BENDIX STREET

NON-MATERIAL AMENDMENT REPORT

D480-TGA-RP-FL_90_72-0001

16.02.23 - ISSUE 1

SITE PLAN

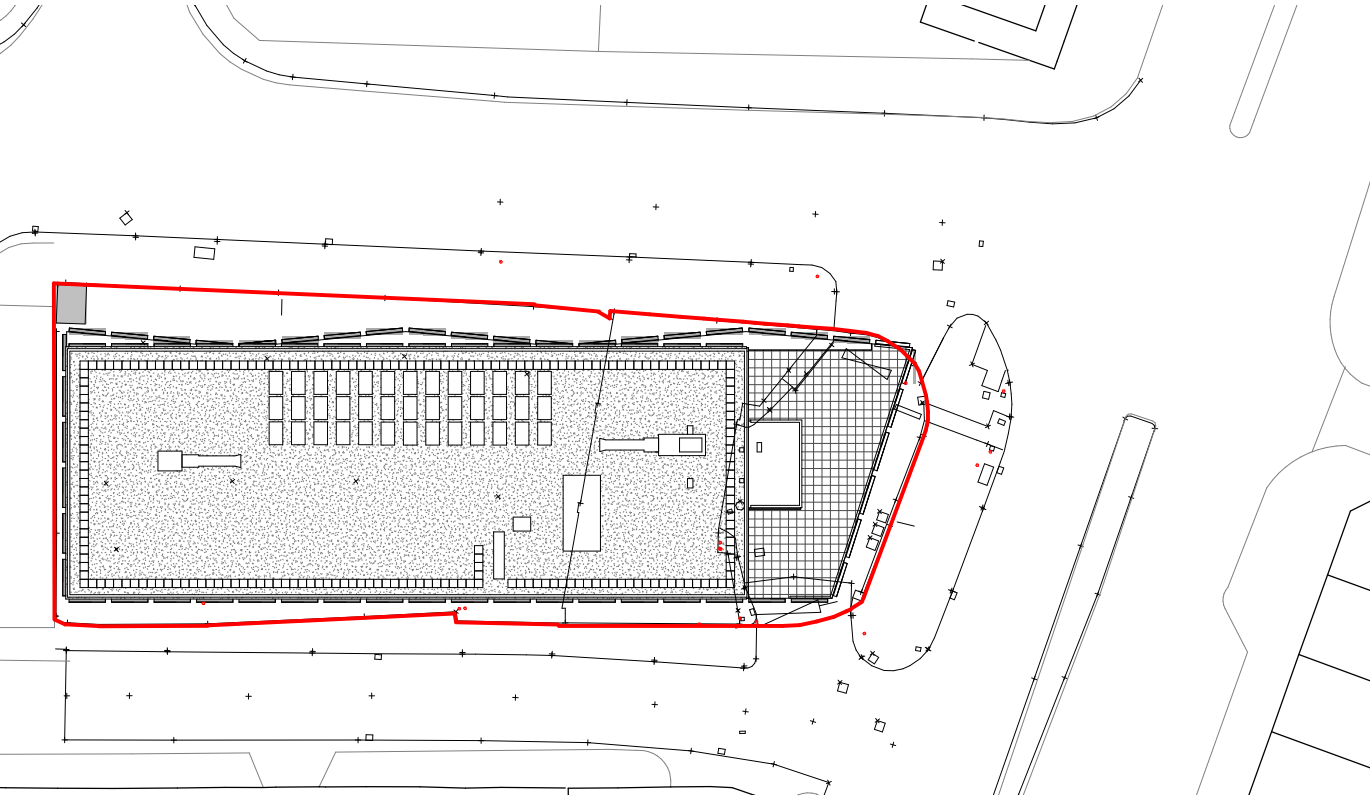
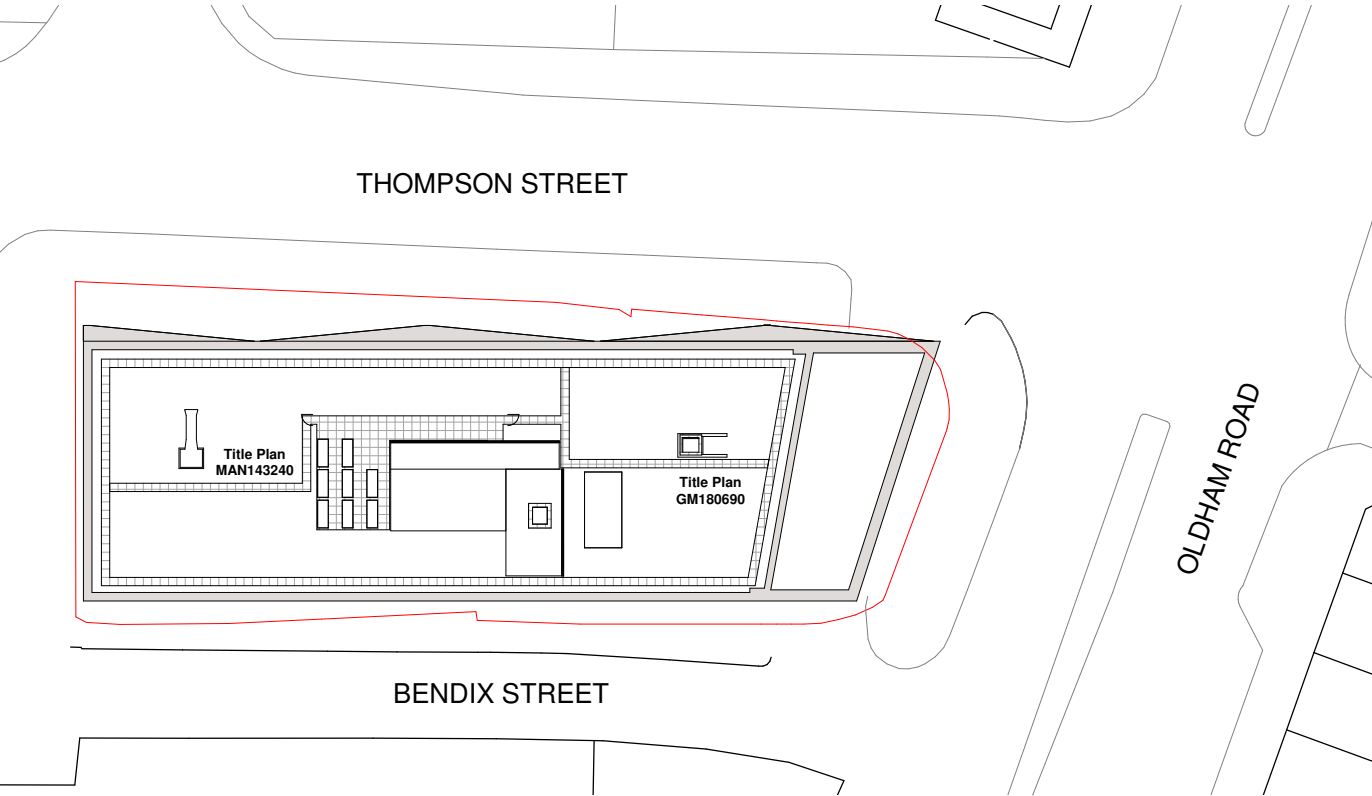
The setting out of the building relative to the site boundary has been reviewed since the consented planning application.

Moving the building 300mm towards Oldham Road ensures that windows on the North-West elevation have glazing more than 1 metre away from the site boundary line.

This permits openable windows to be used on this elevation. Without this change, windows along this elevation could not have openable panes, and would need to be fire-rated to meet the requirements of AD B of the building regulations.

The principle of the building's upper floors (level 2 and above) oversailing the footway is unchanged from the consented proposal, and will just be adjusted to the new dimension., as shown on the right of the image below.

The changes to the consented site plan are relatively minor, and are outlined in the drawing extracts below.

2.1 PERFORATED PANEL - PATTERN DESIGN

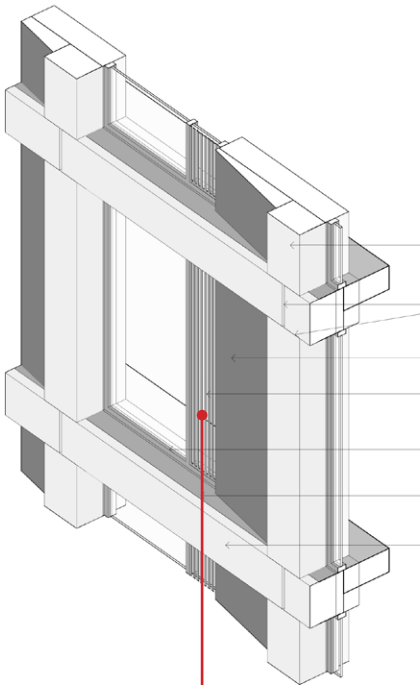
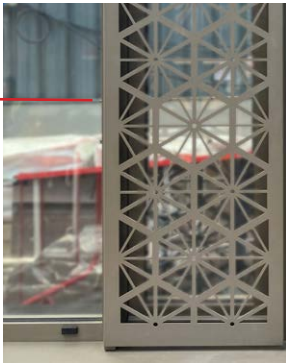
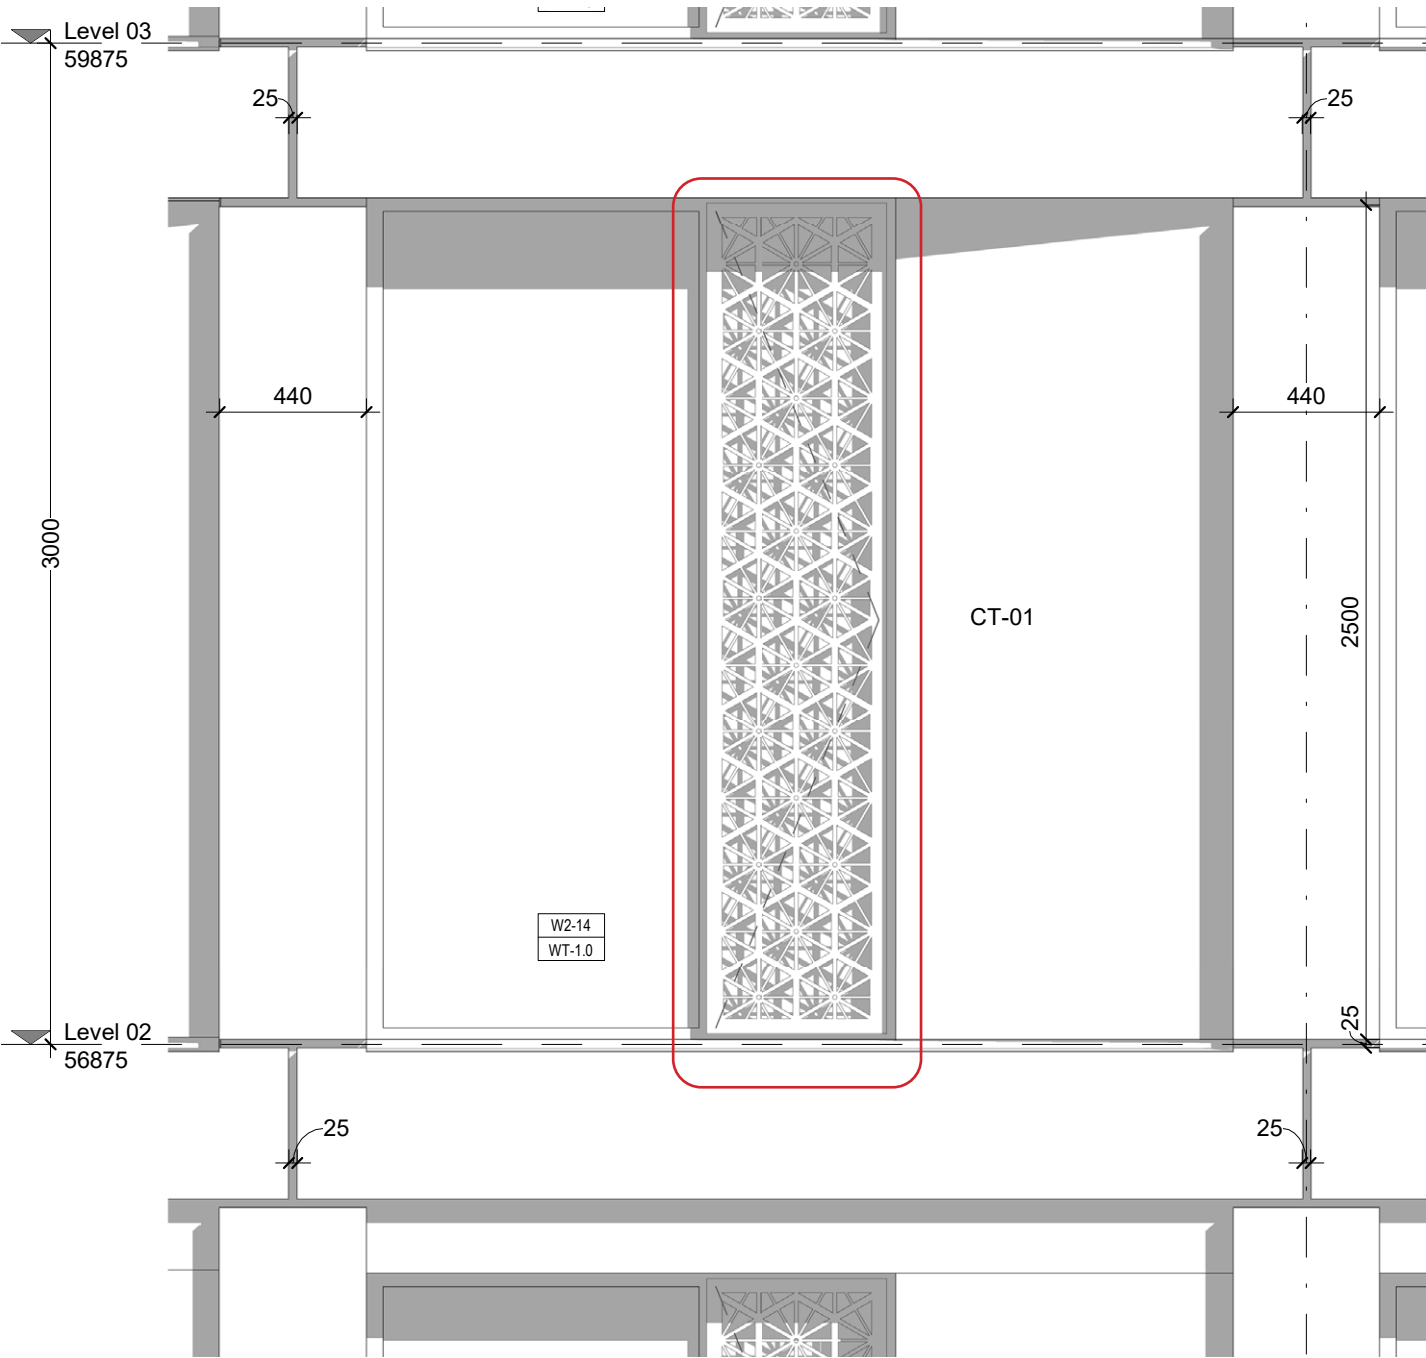
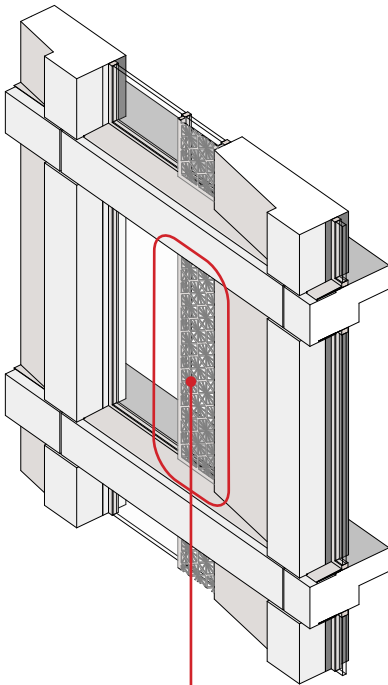
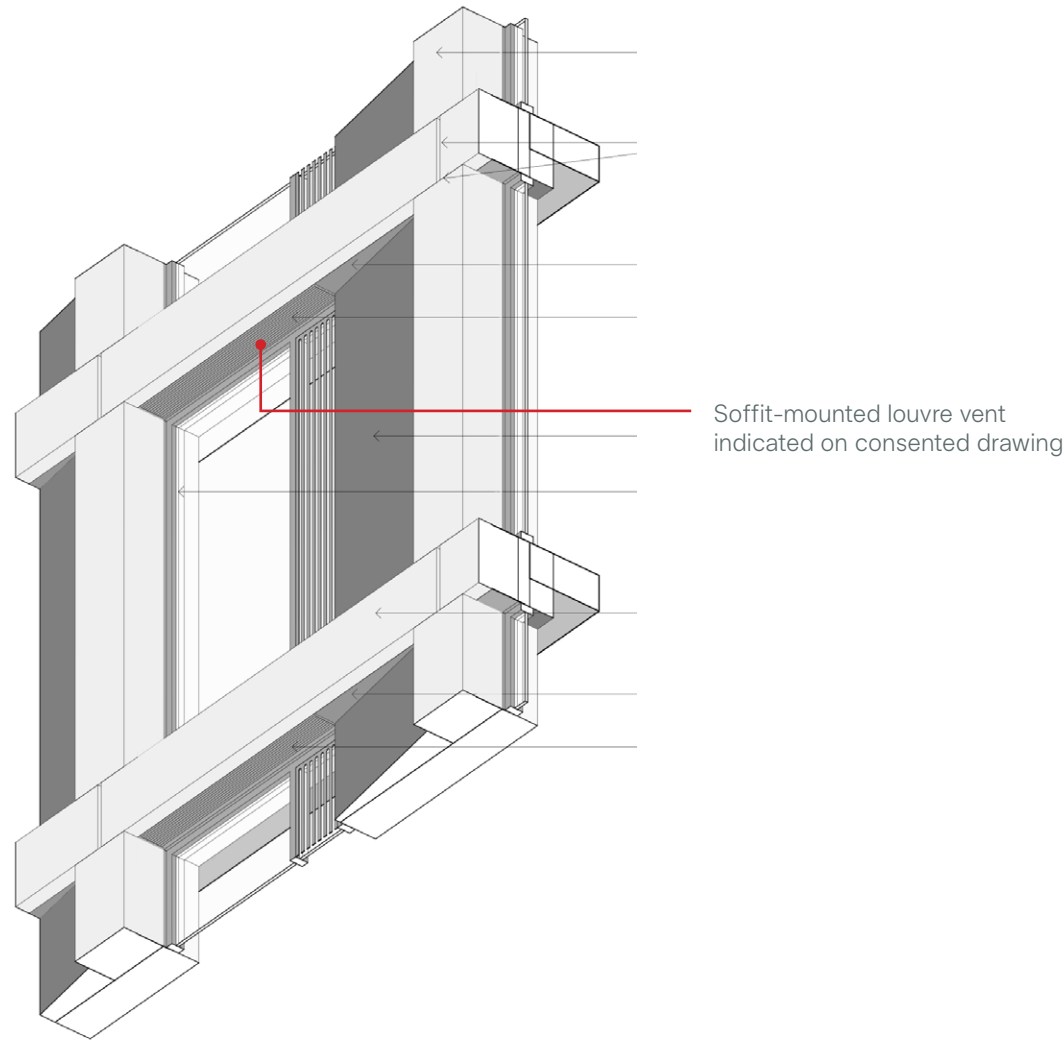
The perforated panel screening opening window panes presents an opportunity to add ornamentation and detail to the building's facade. The pattern is indicated on this page and references the history of the site and its previous uses. Historically a Sunday school stood on the site. This was founded by a local industrialist, whose umbrella factory funded the school.

The proposal shown here has been demonstrated on the materials sample panel, developed via review and discussions of the panel with persons from Manchester City Council planning department.

Panel with vertical slots indicated on consented drawing

Perforated pattern panel
Sample panel of proposal,
photo as installed late 2022

2.2 PERFORATED SOFFIT TRIM REPLACES LOUVRE

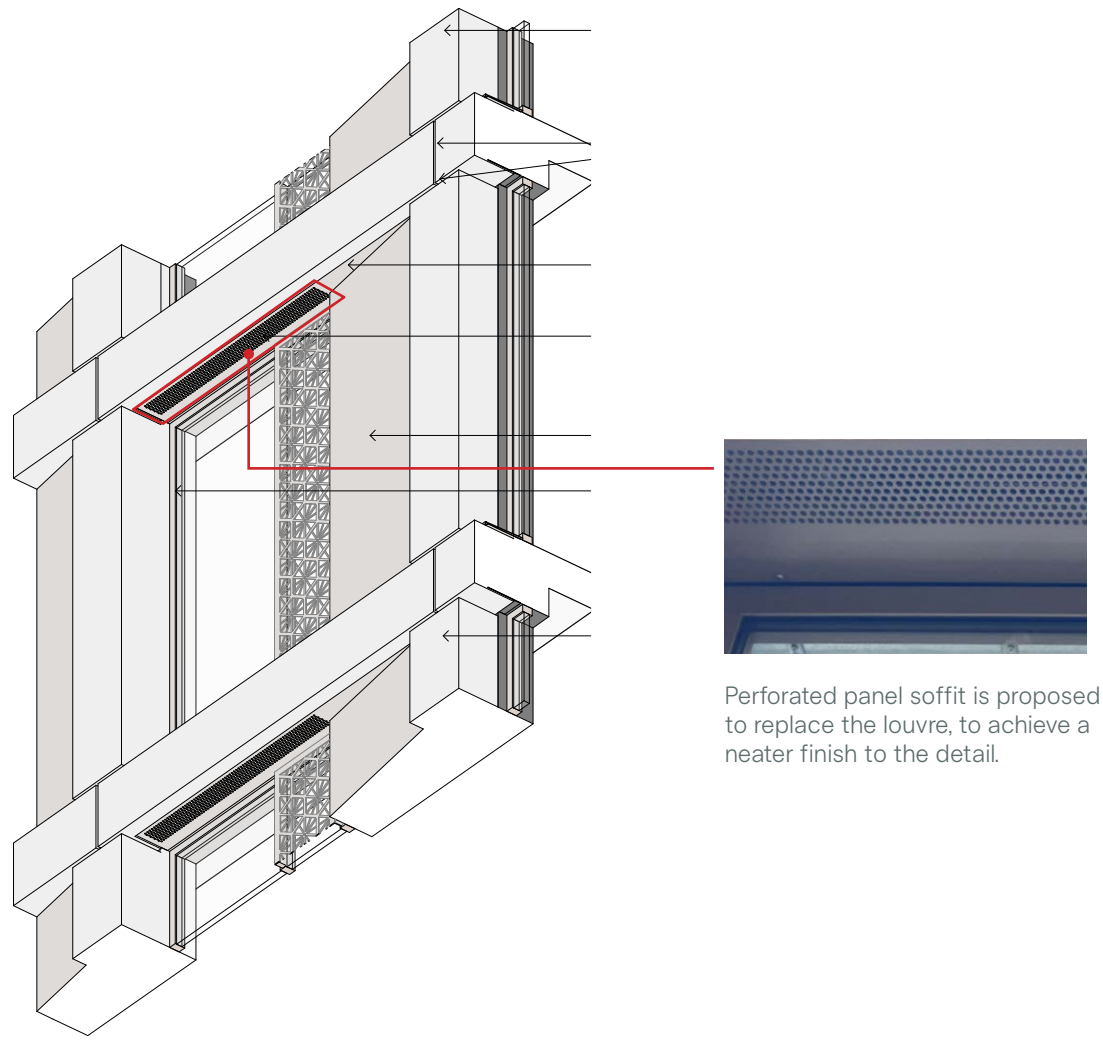
Ventilation systems which terminate to air at window heads have been reviewed. To achieve a neater detail the change below is proposed.

This proposal has been demonstrated on the materials sample panel, which has been developed via reviews and discussions of the panel with persons from Manchester City Council planning department.

GROUND FLOOR PLAN & FIRST FLOOR PLAN

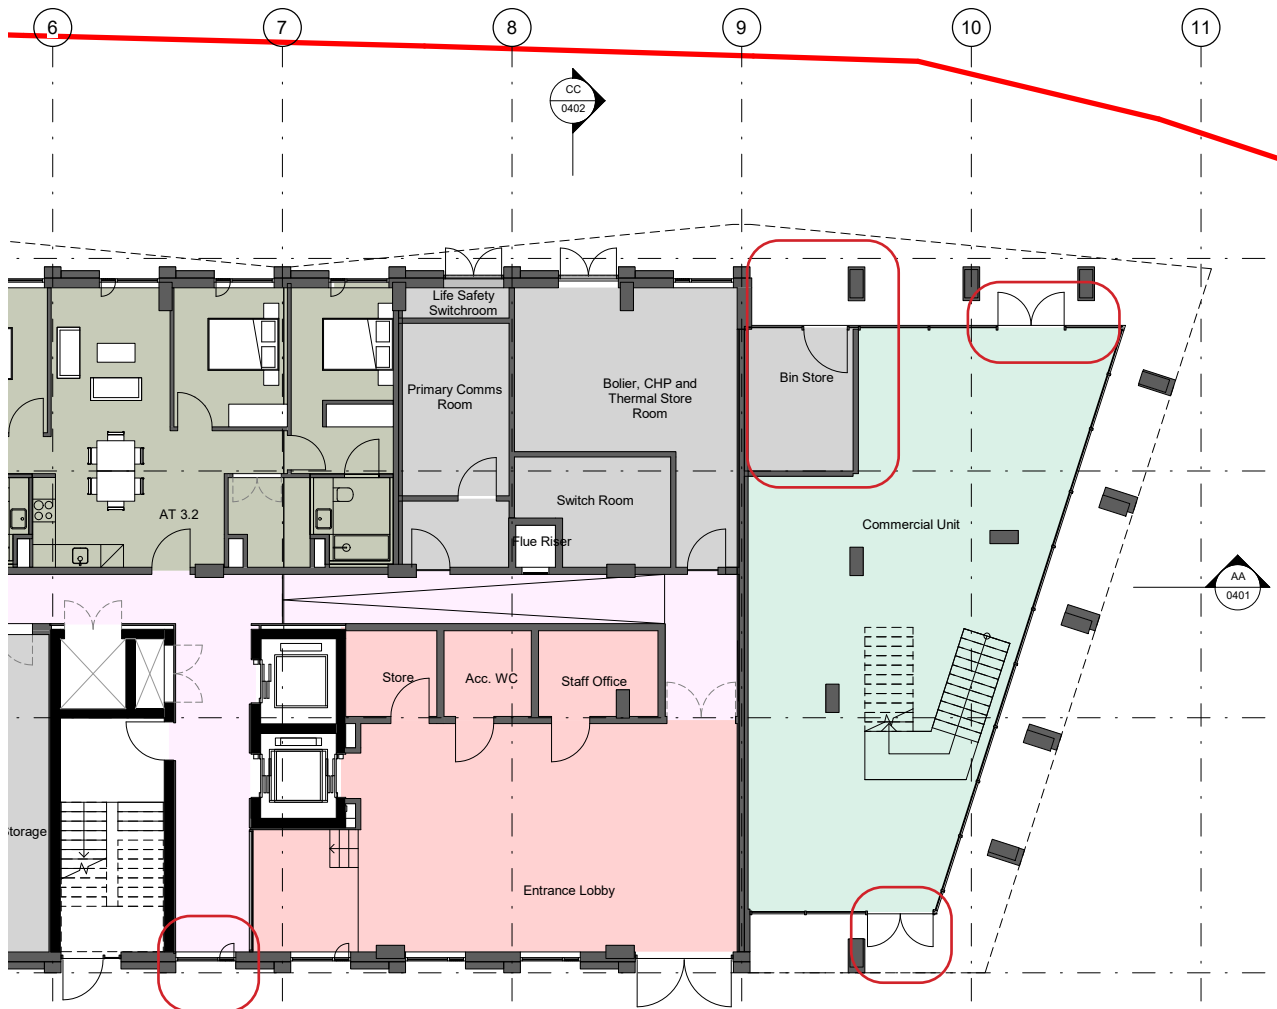
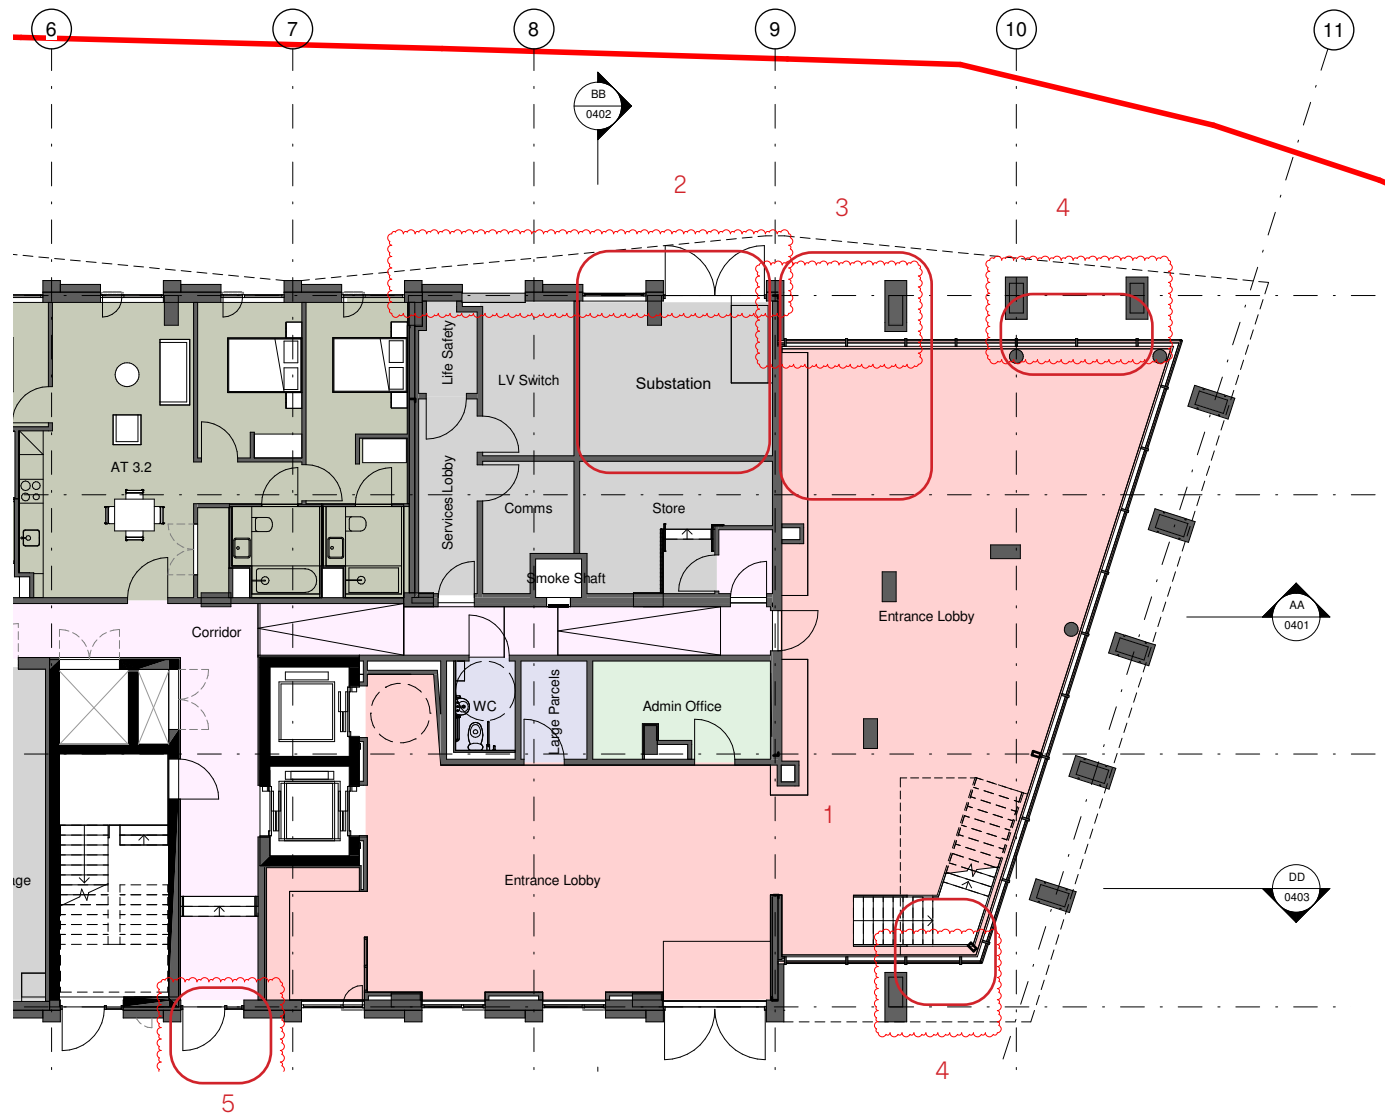
The Commercial Unit and associated storage/servicing space will now be used as amenity space for the residents of the building.

This affects the ground floor plan as highlighted in the extracts below.

- 1. Ground Floor commercial unit changed to be used as Residents Lounge
- 2. Substation replaces plant room - larger doors required Note: detailed design of door to meet requirements of utility provider
- 3. Commercial unit and separate bin store omitted
- 4. Associated double doors omitted
- 5. Additional operations / maintenance access door at ground floor
